Groundwater Transfer Review Summary Form

Transfer/PA # T- 13795

Application: T-13795

Applicant Name: Borror

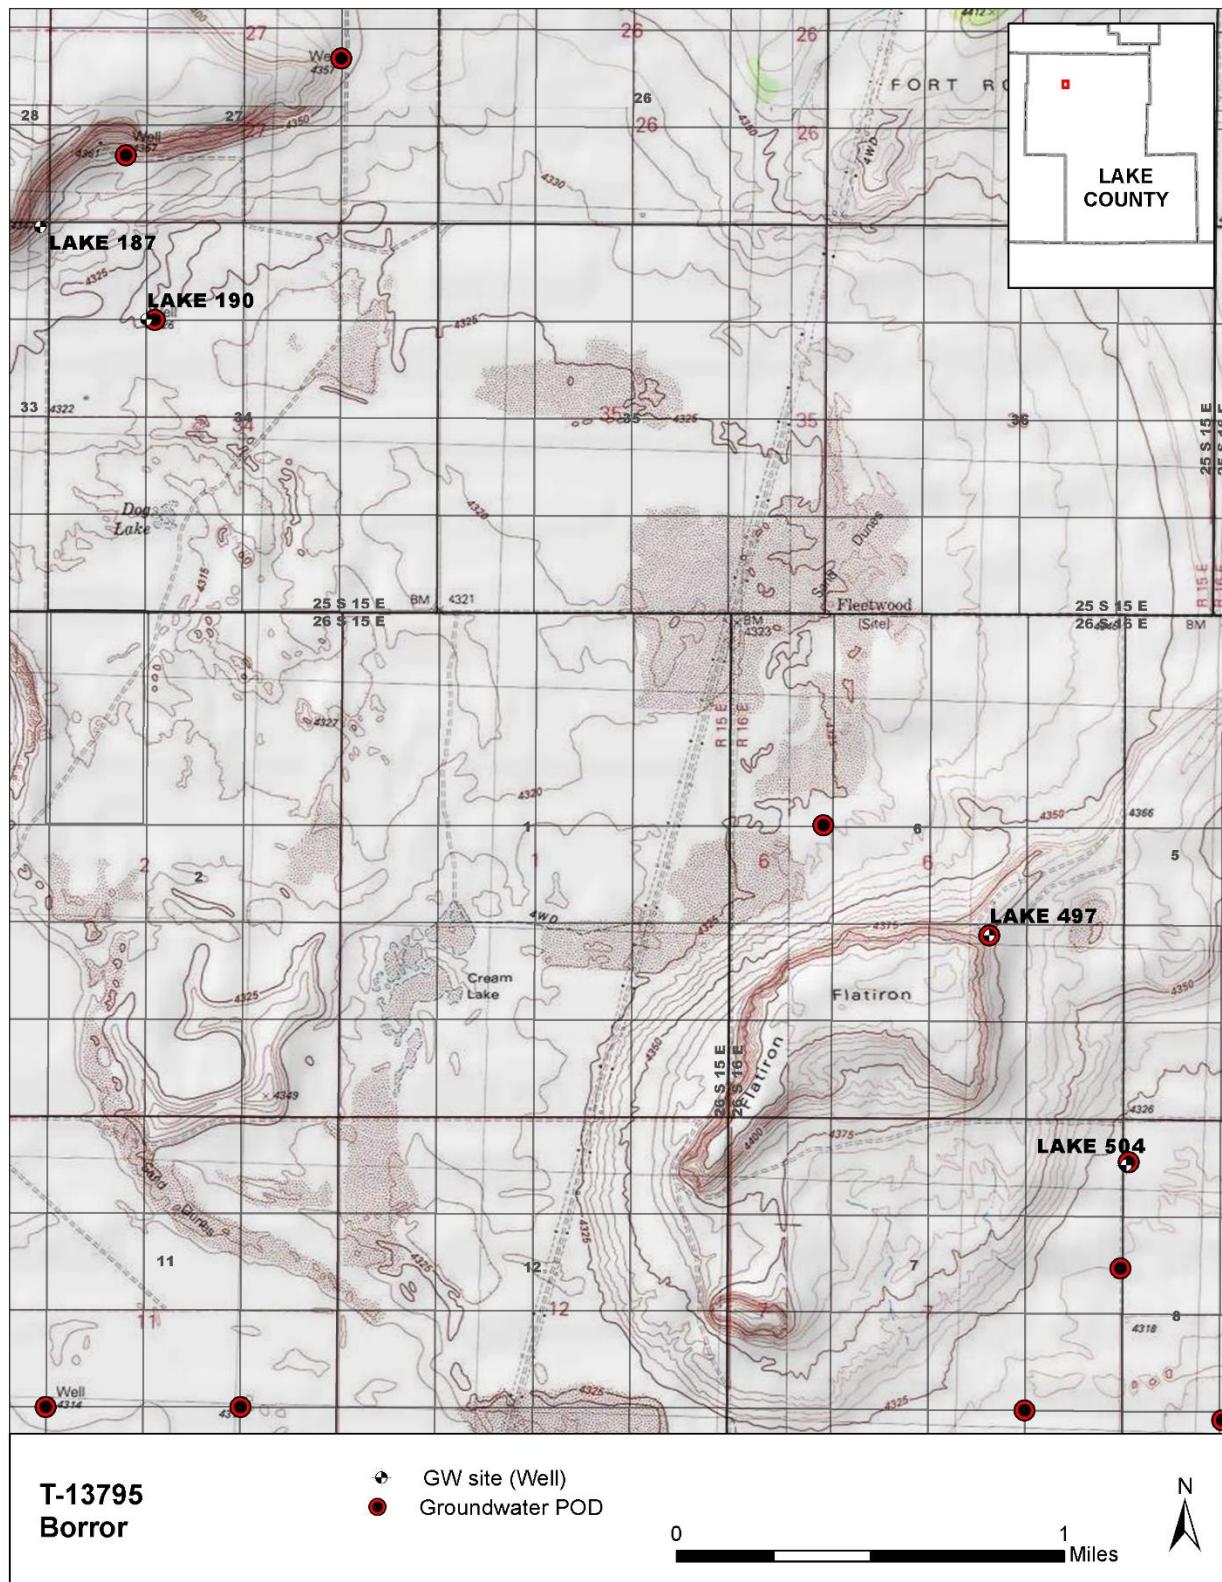
The long term impact on the groundwater system should be the same. That impact is to continue contributing to the ongoing annual Fort Rock Classified area groundwater level decline. See attached hydrograph.

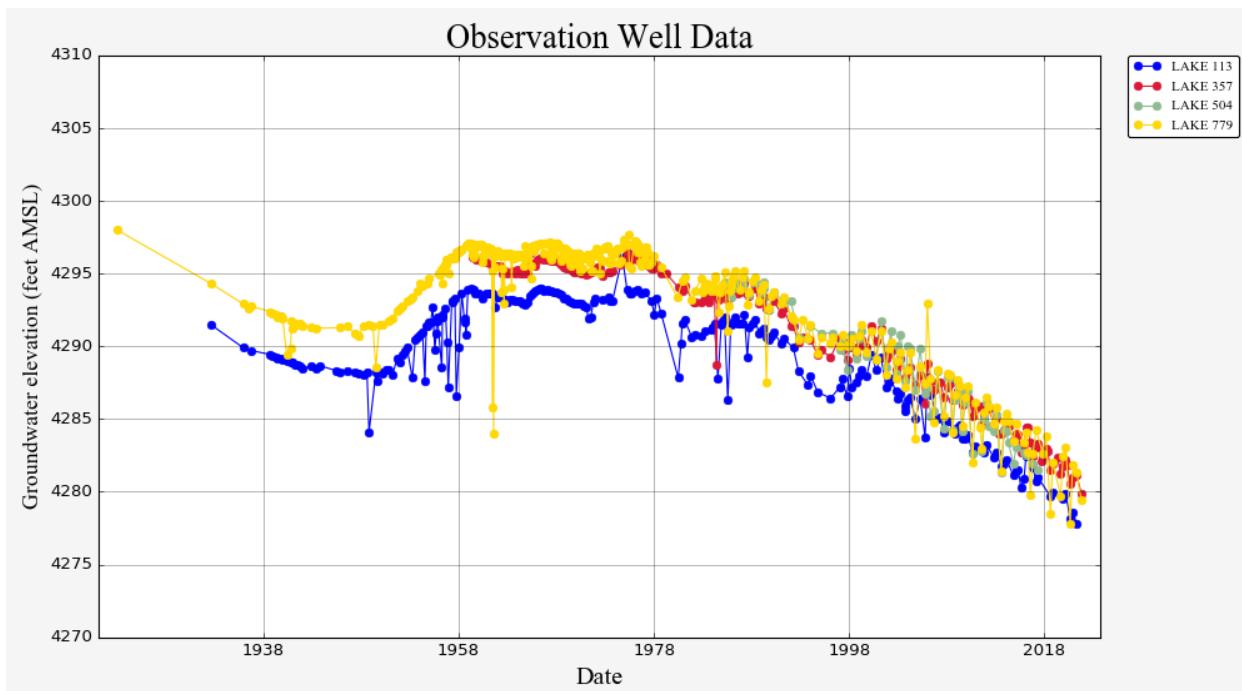
The nearest authorized well under different ownership to the proposed APOA is POD 1 under certificate 63611 (LAKE 504) which is located ~3700 feet to the southeast. The potential increase in drawdown was calculated using the Theis equation (see attachments). The values used for the calculation are conservative and appropriate until better values become available. The calculation used an intermediate storage coefficient (0.001). The transmissivity used in the calculation (15,000 ft²/day) is from Morgan (1988) and McFarland and Ryals (1991). At the pro-rated pumping rate of the full duty over the full irrigation season (0.17 cfs), the results indicate a drawdown of <1 foot, which should be within the capacity of the nearby well.
